Dominion Nuclear Connecticut, Inc. Millstone Power Station Rope Ferry Road Waterford, CT 06385

Docket No. 50-336 B18724

## Millstone Nuclear Power Station, Unit No. 2 Technical Specifications Change Request 2-15-02 Changes In Technical Specifications Related To Reactivity Control Systems, <u>Power Distribution Limits, And Special Test Exceptions</u>

Technical Specifications Change Request 2-15-02 Changes In Technical Specifications Related To Reactivity Control Systems, Power Distribution Limits, And Special Test Exceptions <u>Discussion of Changes and Safety Summary</u>

3/4.1

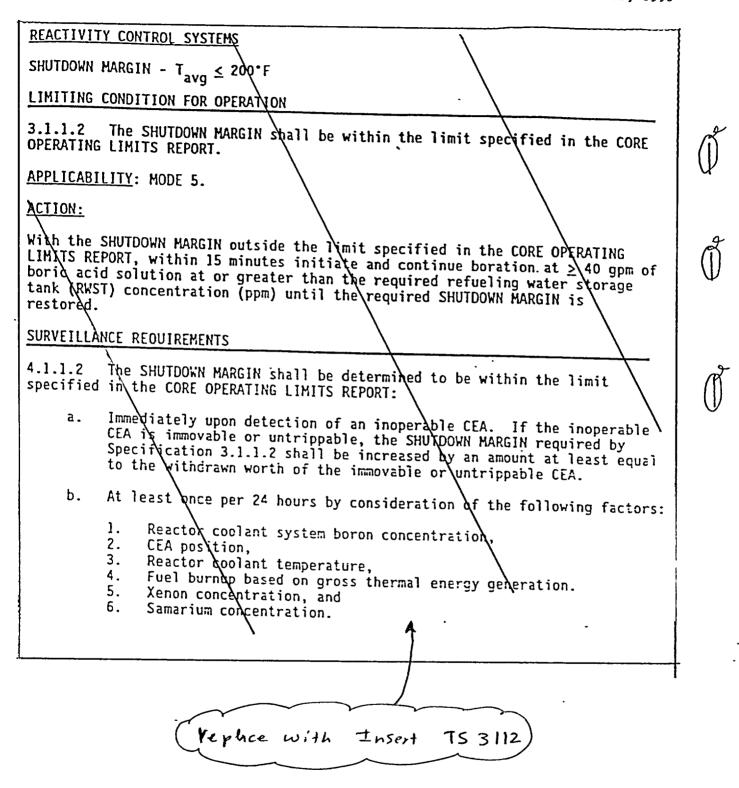
With the SHUTDOWN MARGIN not within the limit specified in the CORE OPERATING LIMITS REPORT, within 15 minutes, initiate and continue boration at  $\geq$  40 gpm of boric acid solution at or greater than the required refueling water storage tank (RWST) concentration (ppm) until the SHUTDOWN MARGIN is restored to within limit.

Amendment No. 185, 215

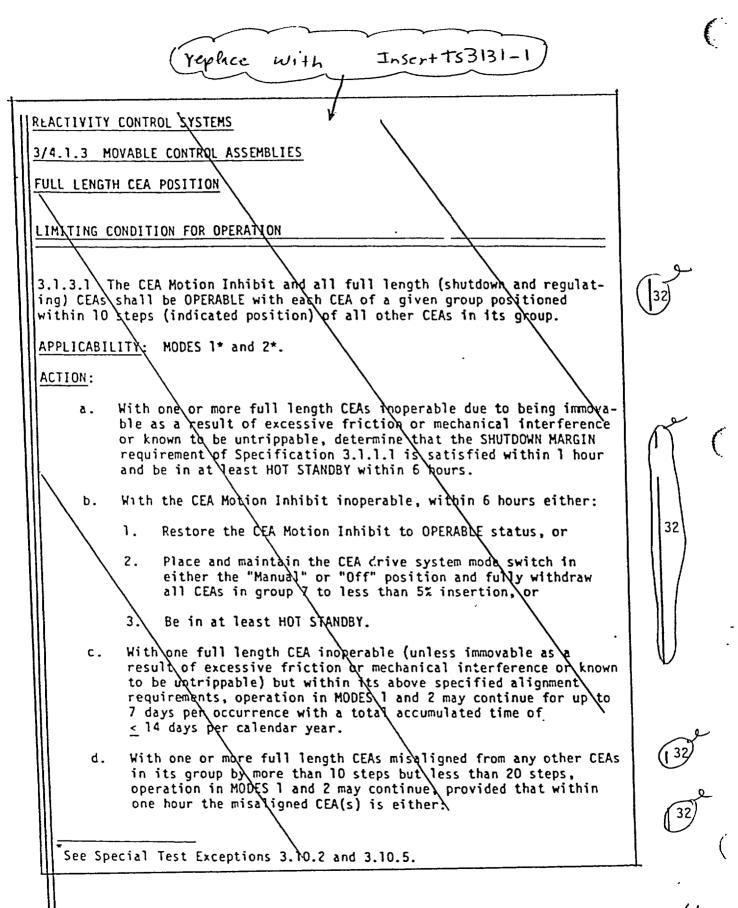
<sup>\*</sup>When the plant is in MODE 1 or 2, reactor coolant pumps are required to be in operation. Therefore, Surveillance Requirement 4.1.1.3 does not have to be performed in MODES 1 and 2. This-exception does not apply if operating in accordance with Special-Test-Exception-3.10.4.
